AIA® Document G710™ – 2017

Architect's Supplemental Instructions

PROJECT: *(name and address)*
57-21113-00 - Rebid Dutchess Stadium
New Left Field Clubhouse, Seating Bowl,
& Restroom Building

ASI INFORMATION:
ASI Number: 006

57-21113-00
 CIVIL UTILITY
 PLAN 1

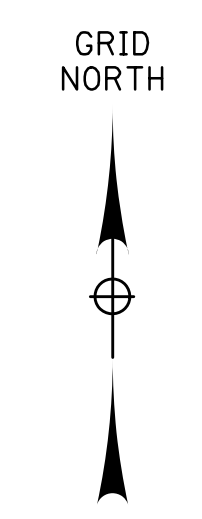
1. Sheet C4.1.ii - CIVIL UTILITY PLAN 1
 - a. Modifications per the attached sheet.
2. Sheet C5.1.ii - CIVIL DETAILS
 - a. Modifications per the attached sheet.
